**Application Number:** 22PLN-37  
**Subject:** Development Review Permit for the construction of a three-story, ±42,000 square foot/80 room Holiday Inn Express on a 2.74 acre portion of an 11.77 acre parcel  
**Location/APN:** 961 Plaza Drive/035-480-039  
**Owner:** Rajinder Singh, Grass Valley Hospitality, Inc.  
**Applicant:** Jeff Morrish, NST Engineering, Inc.  
**Zoning/General Plan:** Central Business (C-2) Zone/Commercial  
**Entitlements:** Development Review Permit

## **Holiday Inn Express Proposed at 961 Plaza Drive**

**REAR ELEVATION - East**  
SCALE 1/8" = 1'-0"

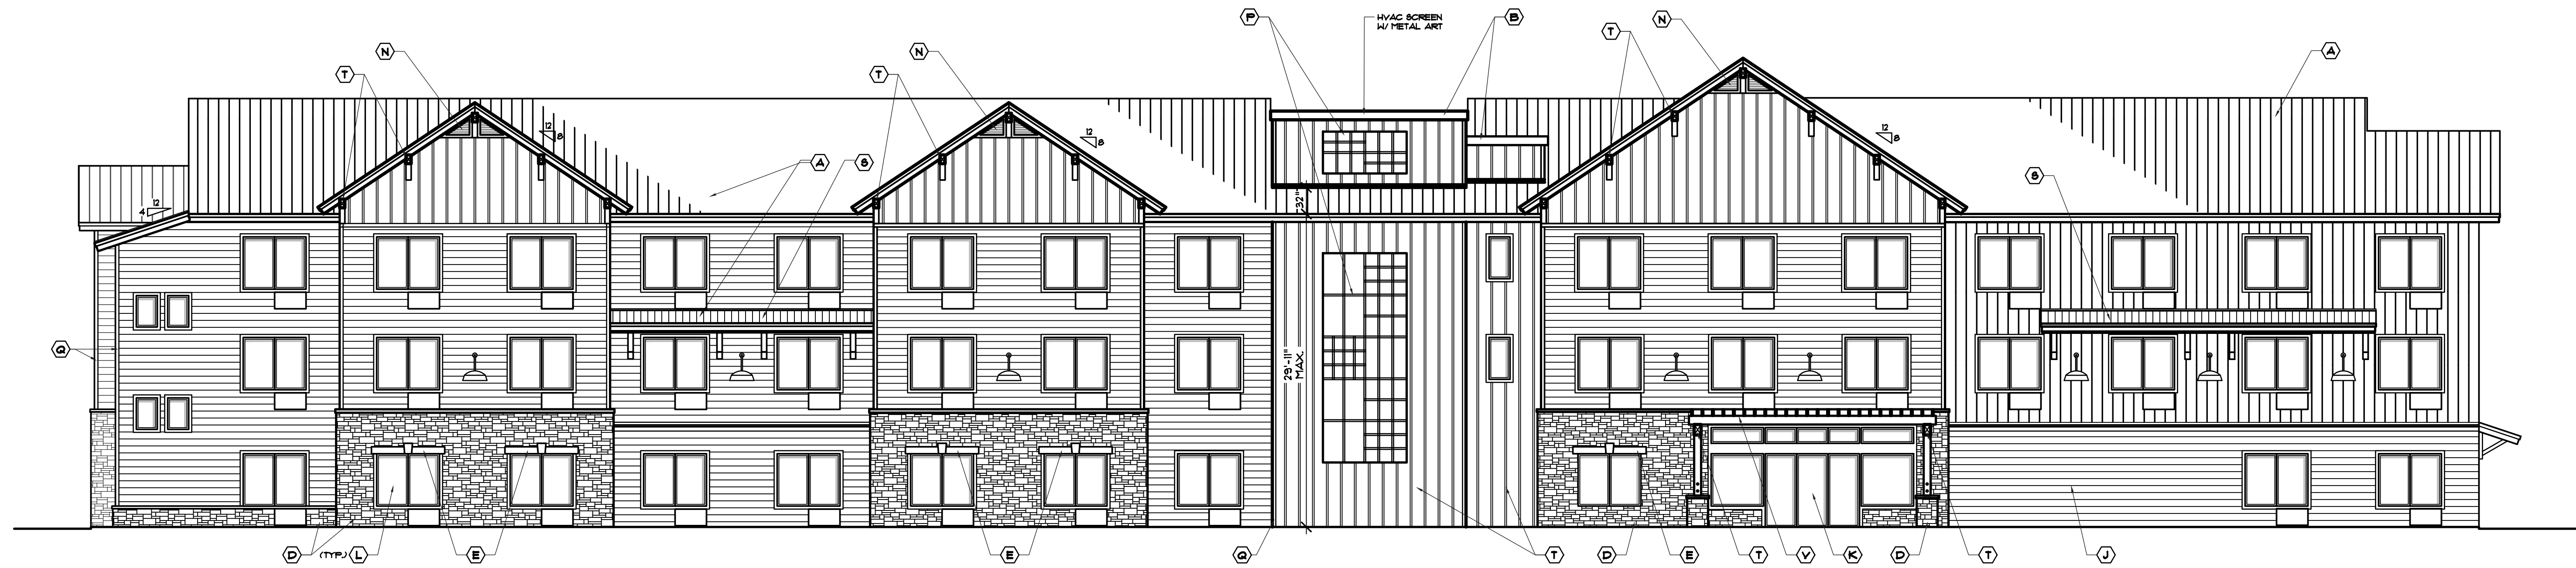
1. The stamped concrete in the porte cochere and rear patio will be tan.
2. The metal art on the rear exterior elevation will be constructed of tubular steel and will be colored black. The art is transparent and will be attached to the wall. The wall color behind the art will be exposed. The art piece will be connected to the wall in such a way that it will set away from the wall plane so that a shadow affect will be created.

6. The area behind the trash enclosure is landscaped.
7. See Sheet A1 for the overall building height and maximum height to the roof eave of 29'-11" for Fire Accessibility.

Sheet No.  
**C3**  
 Of 6 Sheets

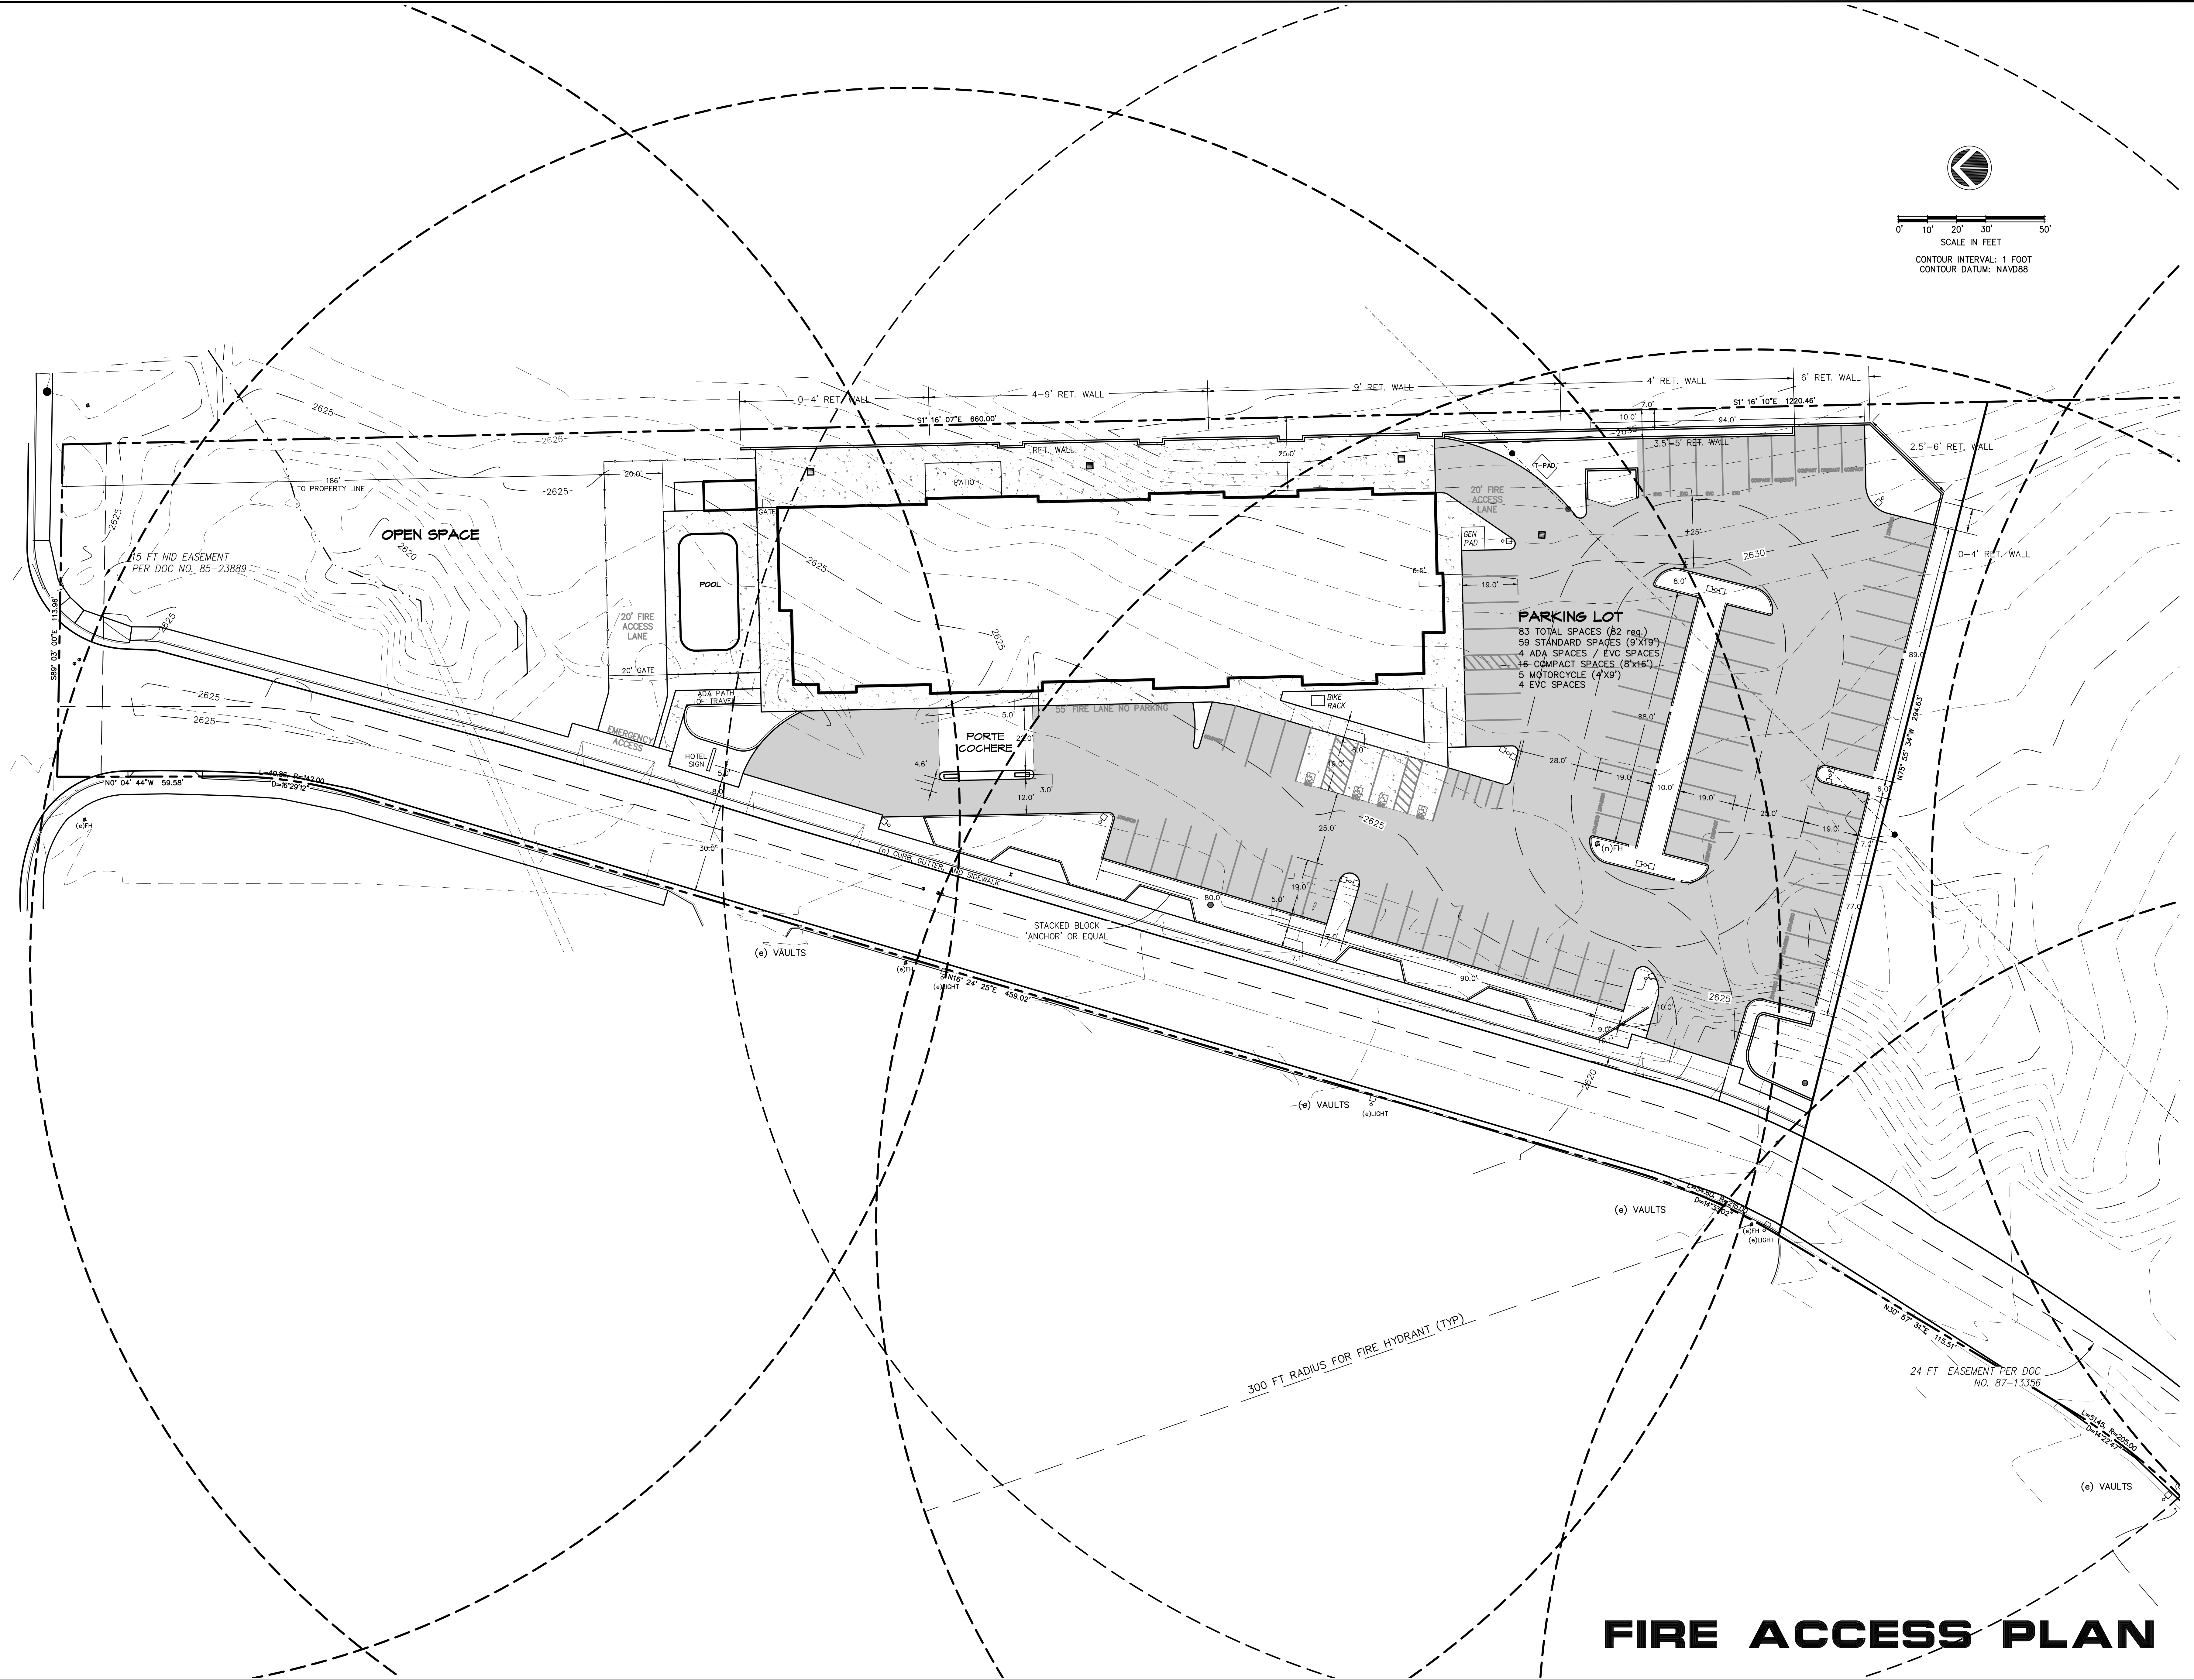
8. Sheets C3, C4, and C6 show the EV charging spaces.
9. The Geotechnical Engineering Study and Cultural Resource Inventory Survey are attached.

Sheet No.  
**C4**  
 Of 6 Sheets

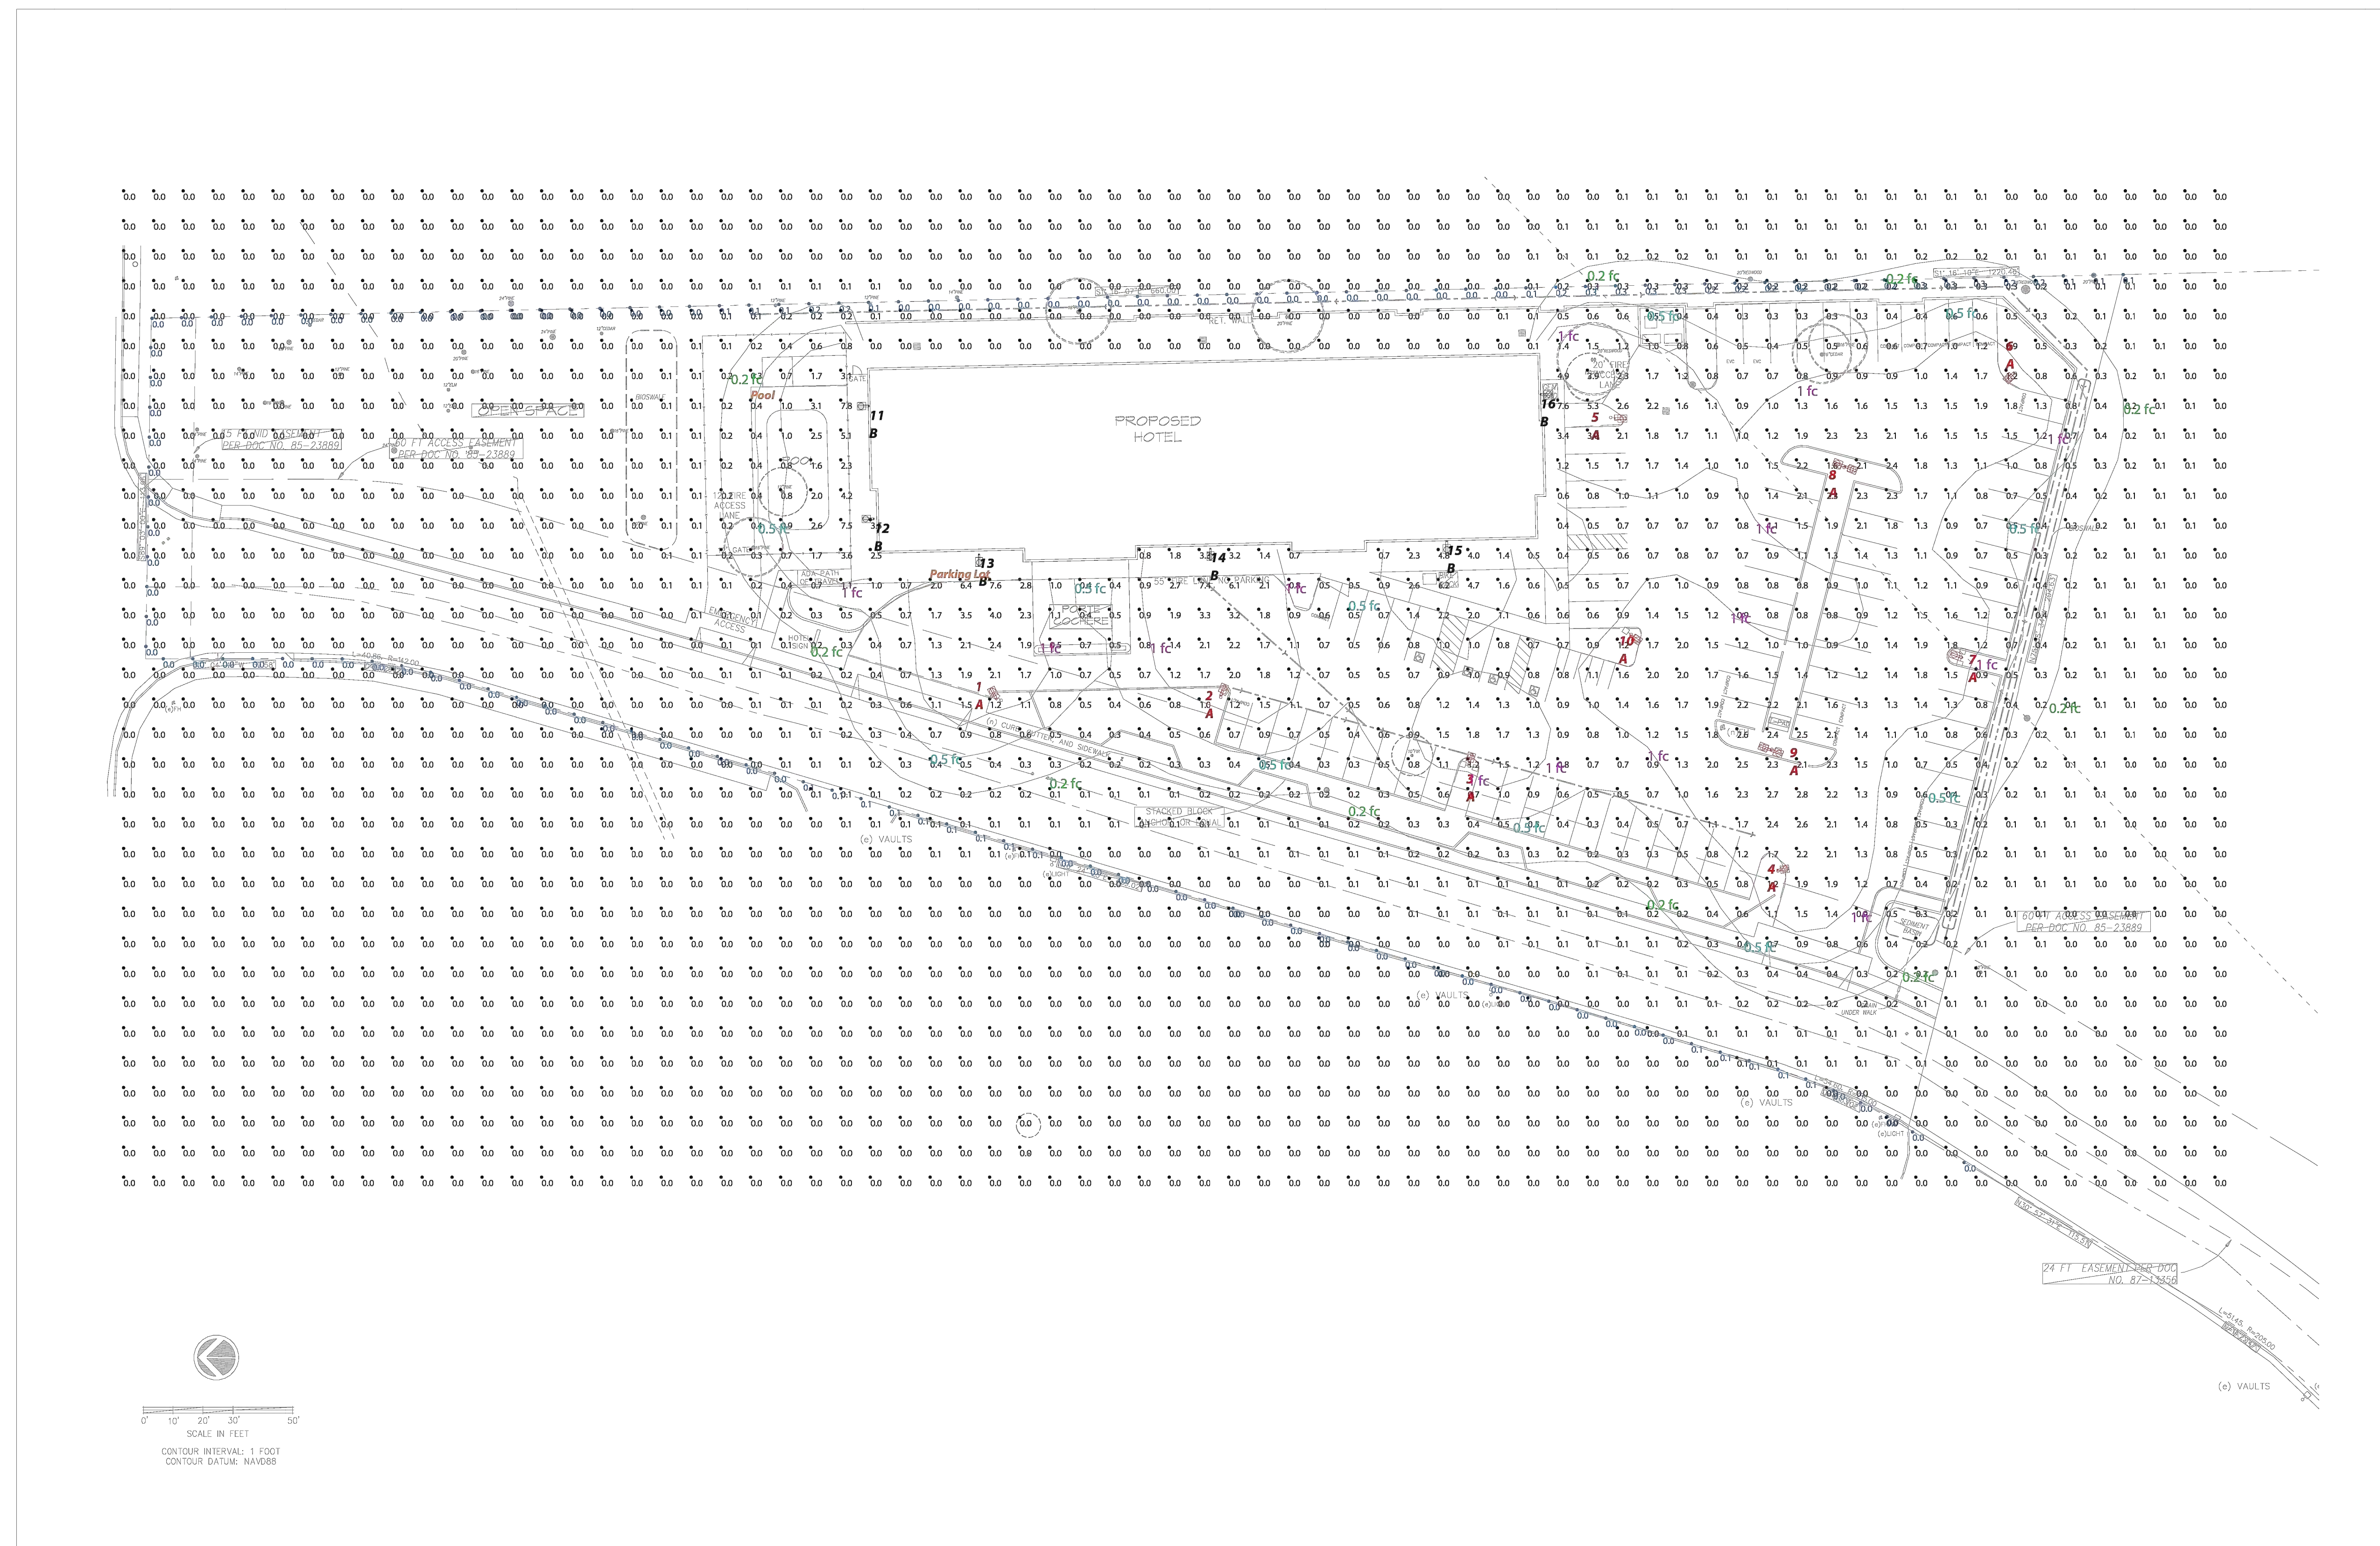
14.
  - a. The fire access road north of the pool and at the southeast corner of the hotel are both designed for twenty (20) feet wide with a twenty foot gate the pool enclosure.
  - b. The exterior elevations have been revised so that the roof eave height is shown as 29'-11" along the west and east elevations allowing access to the entire roof. The parapet walls that enclose the roof mounted equipment are moved back from the roof eaves six (6) feet. The equipment is accessible from the roof along its north, south, and west sides. The gable roofs that were in the second iteration or submittal of our design have been raised about eighteen (18) inches at the eave for aesthetic reasons. These gable roofs are still accessible from the main roof structure and its eave, allowing total accessibility of the roof by a ladder at the roof eave.
